Re: Water Quality Certification for U.S. Army Corps of Engineers Public Notice 1996-4-02325 (Amended-2); Construction of a Third Runway and related projects at the Seattle-Tacoma International Airport (STIA) in the Miller, Walker, and Des Moines Creek watersheds and in wetlands at the Seattle-Tacoma International Airport, located within the vicinity of the city of SeaTac, King County, Washington; and in wetlands at the mitigation site in Auburn, King County, Washington.

ORDER #1996-4-02325 (Amended -2)

Construction of a Third Runway and related projects. Components of the project include construction of a 8,500-foot-long third parallel runway with associated taxiway and navigational aids, establishment of standard runway safety areas for existing runways, relocating S. 154th Street north of the extended runway safety areas and the new third runway, development of the South Aviation Support Area and the use of on-site borrow sources for the third runway embankment.

Borrow Area 3 Wetland and Swale Buffer

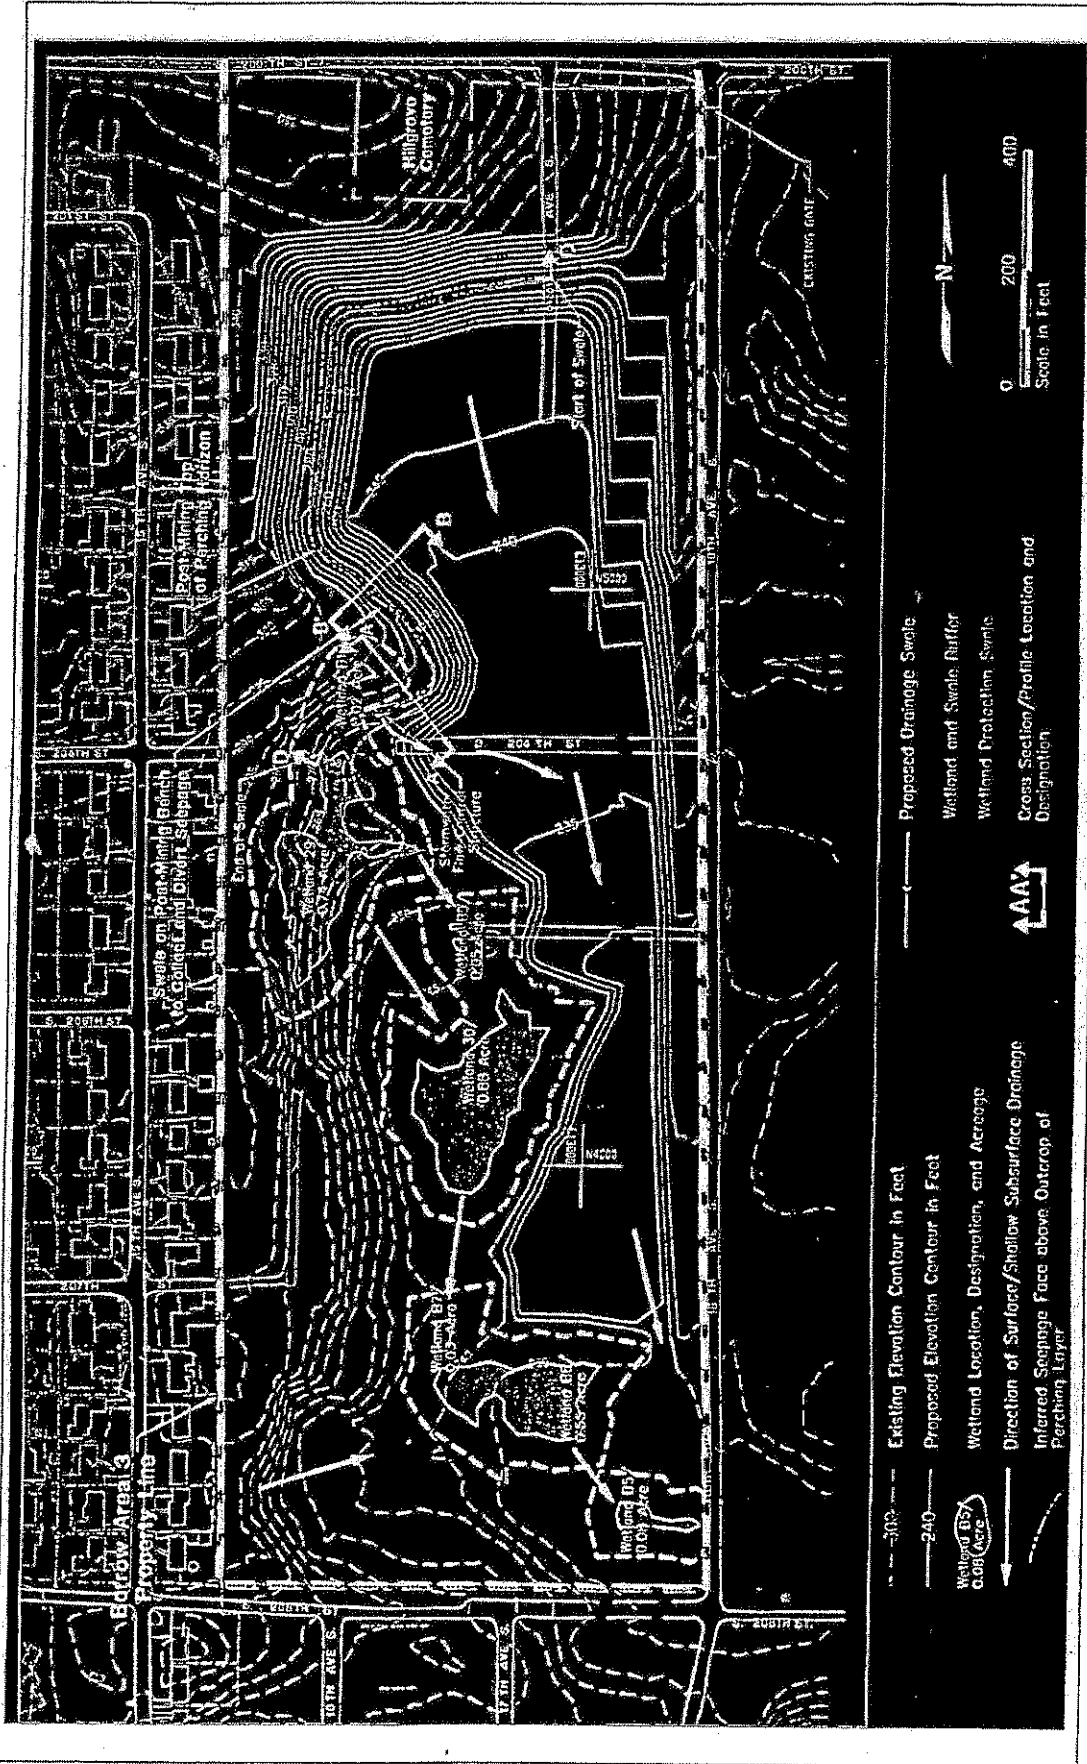
- f) **Increased Buffer Area:** In order to protect the hydrologic functions, and hydrology supporting Wetlands 29, 30, B5, B6, B7, and B9, all areas up slope of the wetlands within the property shall be included in the wetland buffer. Additionally, the Port shall ensure protection of hydrology to Wetlands 29, 30, B5, B6, B7, and B9 from future development. The wetland protection swale shall also be included in a restrictive covenant, with 25 foot buffers on either side of the swale. Those areas are depicted in **Attachment D (Revised)**, Borrow Area 3 Wetland Buffer. A restrictive covenant shall be drafted for this additional buffer area. The restrictive covenant shall be consistent with other restrictive covenants established for this project. The Port shall record the restrictive covenants with King County no later than sixty (60) days after the issuance by the U.S. Army Corps of Engineers of the Section 404 required for construction of the Master Plan Update projects. This condition applies only to property currently owned by the Port.
